NL-15-0240

Edwin I. Hatch Nuclear Plant – Units 1 and 2
Fourth Six-Month Status Report of the Implementation of the
Requirements of the Commission Order with Regard to
Reliable Spent Fuel Pool Instrumentation (EA-12-051)

**Interim Staff Evaluation and Request for Additional
Information – Hatch Nuclear Plant, Units 1 and 2 (HNP)
Regarding Overall Integrated Plan (OIP) for Reliable
Spent Fuel Pool Instrumentation (Order Number EA-12-051)**

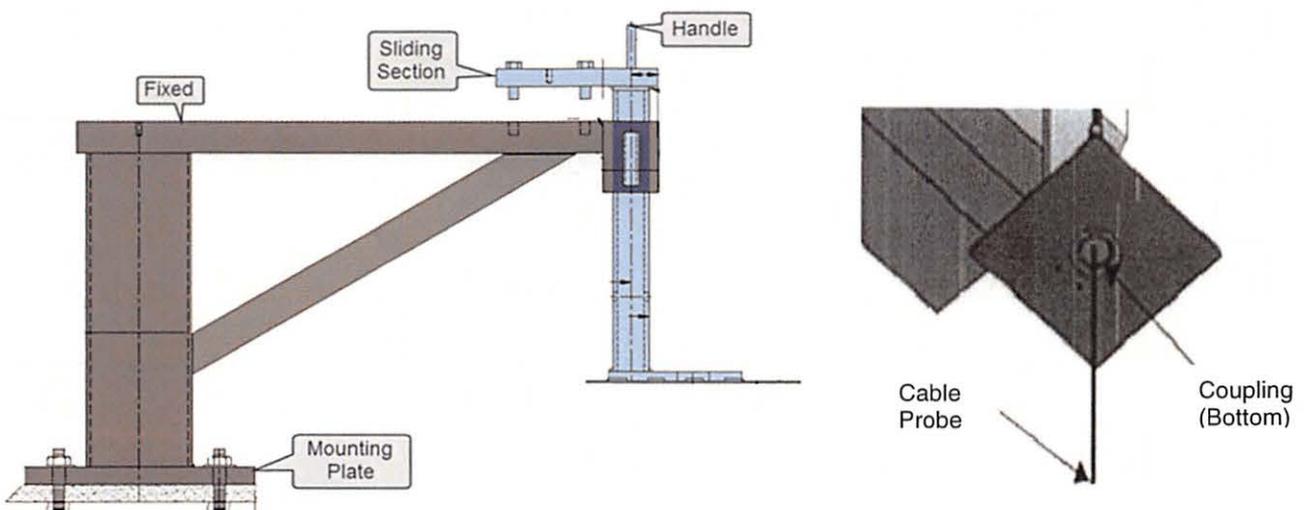
- a) The design criteria that will be used to estimate the total loading on the mounting device(s), including static weight loads and dynamic loads. Describe the methodology that will be used to estimate the total loading, inclusive of design basis maximum seismic loads and the hydrodynamic loads that could result from pool sloshing or other effects that could accompany such seismic forces.
- b) A description of the manner in which the level sensor (and stilling well, if appropriate) will be attached to the refueling floor and/or other support structures for each planned point of attachment of the probe assembly. Indicate in a schematic the portions of the level sensor that will serve as points of attachment for mechanical/mounting or electrical connections.

- c) A description of the manner by which the mechanical connections will attach the level instrument to permanent SFP structures so as to support the level sensor assembly.

- b) The simplified drawing shown below provides a basic representation of the attachment of the probe and the sensor cable to the mounting sliding bracket (launch plate), and mounting bracket attachment to the SFP structure. The mounting bracket will be attached to the SFP concrete floor utilizing expansion-type concrete anchor bolts. The level sensor consists of a stranded stainless steel cable level probe that is threaded on the top end. The probe attaches (threads) into a coupling that is secured to the mounting bracket launch plate and extends down into the pool. The attachment to the signal cable is via a coaxial connection on the top side of the launch plate coupling. The Edwin I. Hatch Nuclear Plant Units 1 and 2 SFPI will not involve use of a stilling well.

- c) The simplified drawing below shows a representation of the attachment of the probe and the sensor cable to the mounting bracket (launch plate), and mounting bracket attachment to the SFP structure.

The level sensor (probe) is designed to be attached near its upper end to the mounting bracket. The mounting bracket will be attached to the SFP concrete floor utilizing expansion-type concrete anchor bolts. The mounting bracket to the SFP concrete floor anchorage is designed to meet the requirements of the Hatch design and licensing basis for Seismic Category I components including seismic loads, static weight loads and hydrodynamic loads.

**Hatch Unit 1 and Hatch Unit 2
Elevation View of Level 1, 2, 3 and Instrument Range**

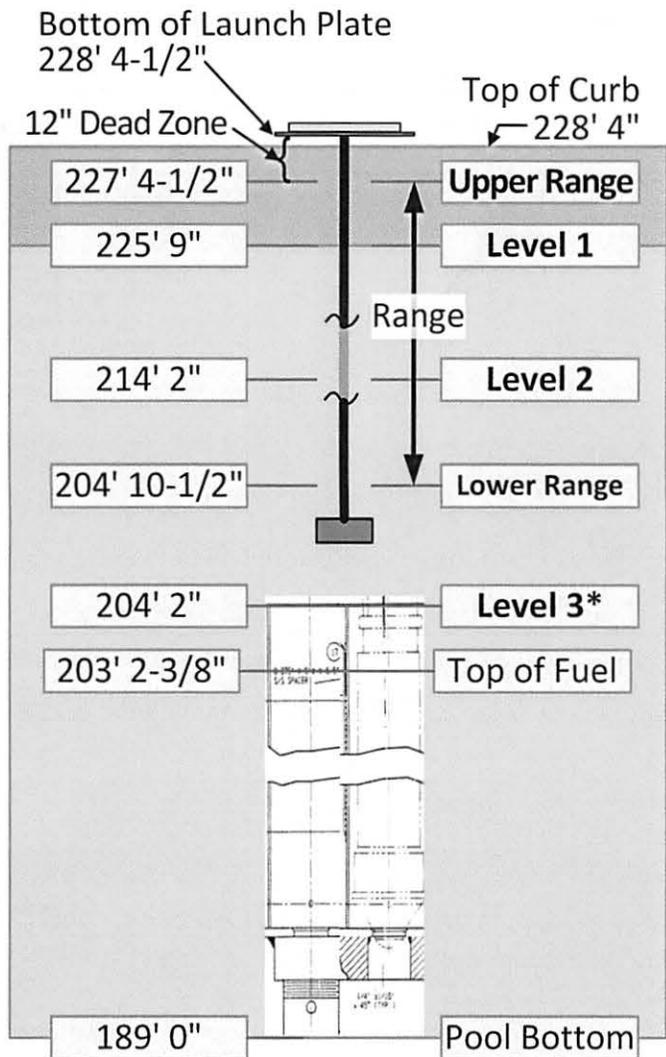
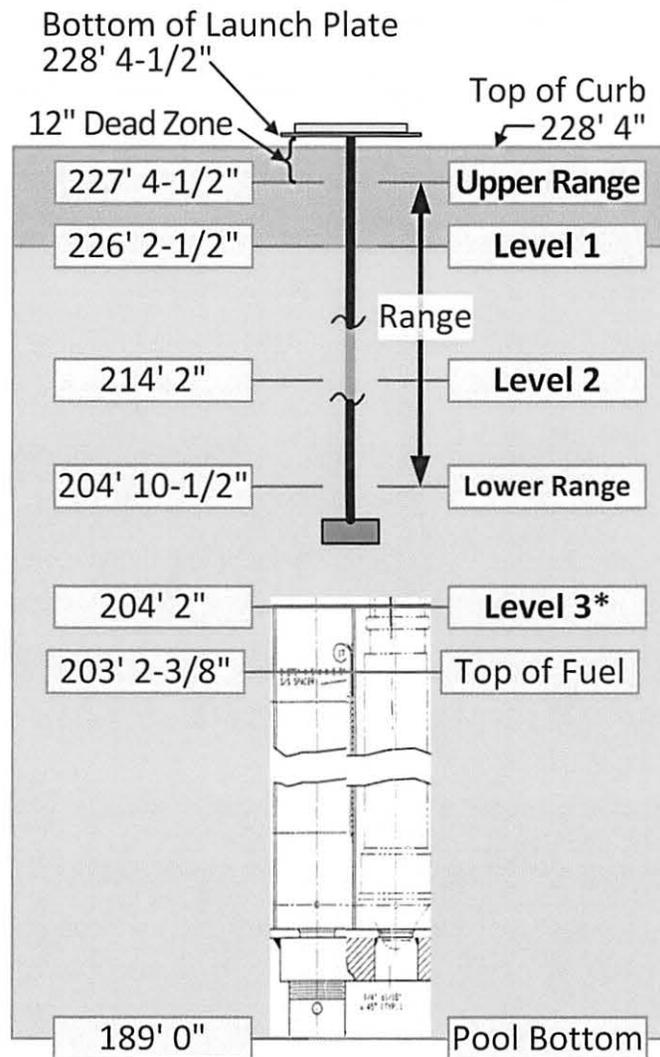
Although not identified by Reference 5 as an open item, SNC stated its intent in Reference 4 to provide: (1) a clearly labeled sketch depicting the elevation view of the proposed typical mounting arrangements for the portions of instrument channel equipment (e.g., fixed level sensors and/or stilling wells, and mounting brackets), (2) datum values representing Level 1, Level 2, and Level 3 as well as the top of the fuel racks, and (3) the portion of the level sensor measurement range that is sensitive to measurement of the fuel pool level, with respect to the Level 1, Level 2, and Level 3 datum points. This information is provided in Enclosure 3.

**Hatch Unit 1 and Hatch Unit 2
Proposed Sensor Location and Conduit Routing
on Elevation 228'**

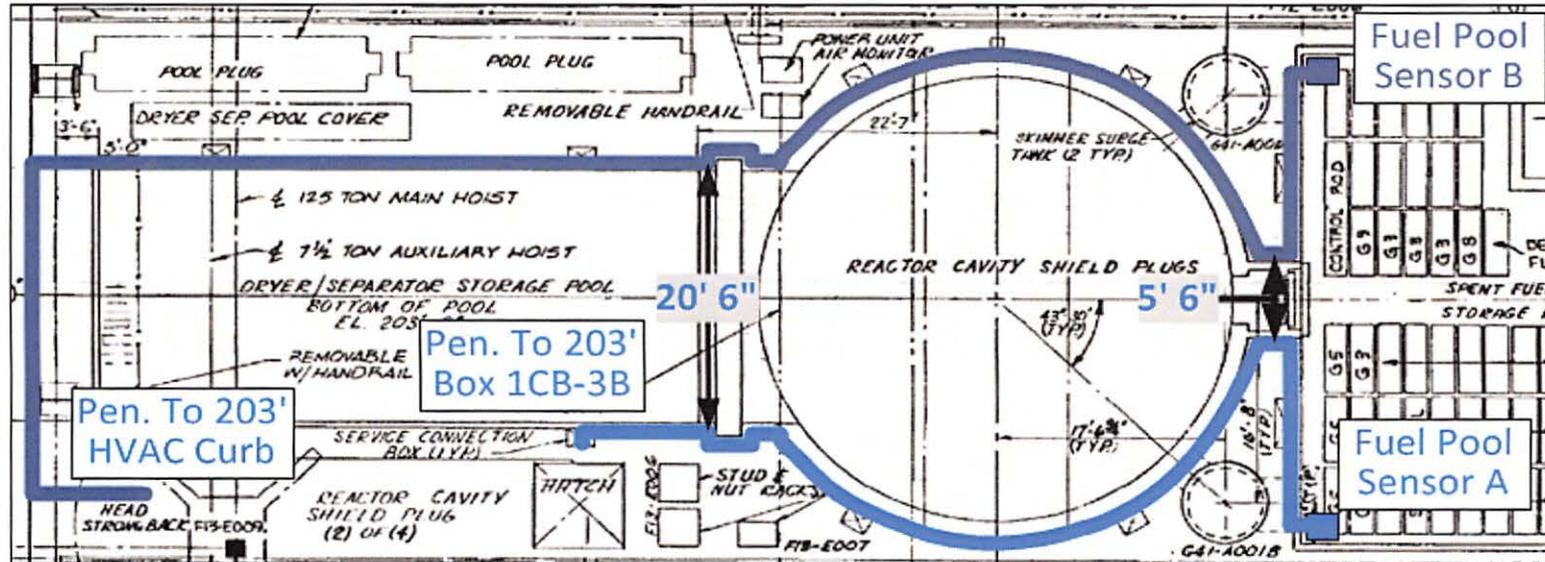
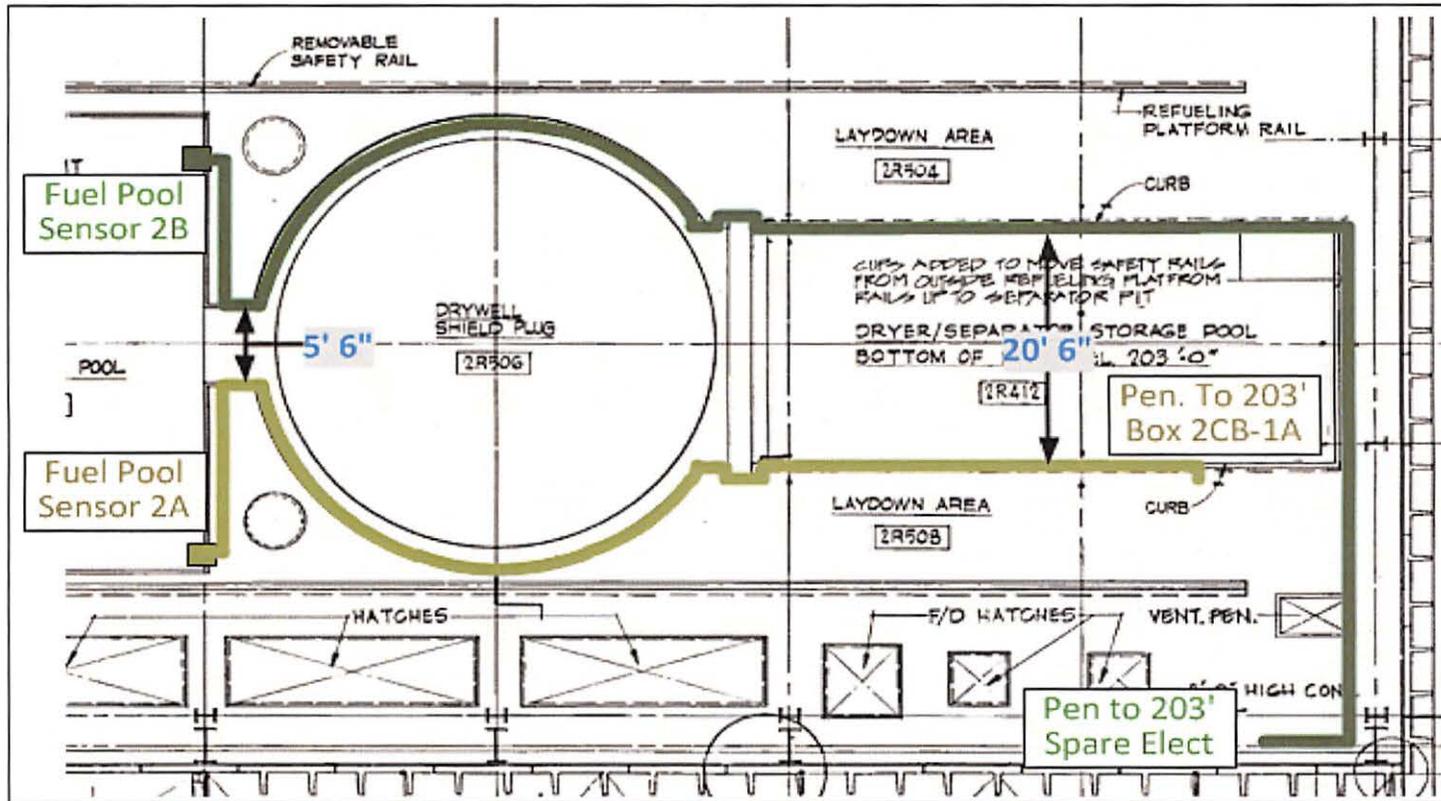
Please provide additional information describing how the proposed arrangement of the routing of the cabling between the level probes and the electronics cabinets that process the signal meets the Order requirement to arrange the SFP level instrument channels in a manner that provides reasonable protection of the level indication function against missiles that may result from damage to the structure over the SFP.

Please provide additional information describing how the proposed arrangement of the SFP level instrumentation meets the Order requirement to arrange the SFP level instrument channels in a manner that provides reasonable protection of the level indication function against missiles that may result from damage to the structure over the SFP.

By letter NL-13-0172 dated February 27, 2013, SNC provided the Hatch Overall Integrated Plan (OIP) required by Order EA-12-051. Attachment 1 of the OIP provided a probe layout sketch depicting the Spent Fuel Pool Level Instrument (SFPLI) probe locations and corresponding cable routing associated with each based on available information. SNC has chosen to relocate the SFPLI probes to eliminate the need to route both instrument channels in close proximity of one another. A plan view sketch of the Unit 1 and Unit 2 SFP areas is provided in Enclosure 4, depicting the location/placement of the primary and alternate level sensors, and the routing of cables that extend toward the location of the electronics. To provide reasonable protection of the level indication function against missiles that may result from damage to the structure over the SFP, the primary and alternate channel cabling will be routed in flex conduit inside steel plate-covered trenches and physically separated to the extent practicable.

As stated in response to RAI #1 above, SNC has relocated the SFPLI probes from the location depicted in the OIP dated February 27, 2013. Enclosure 4 provides the revised location for the Unit 1 and Unit 2 SFPLI probes. Physical separation of the primary and alternate channels, to the extent practicable and comparable to the short side of the pool, is used to provide reasonable protection of the level indication function against missiles that may result from the damage to the structure over the SFP.
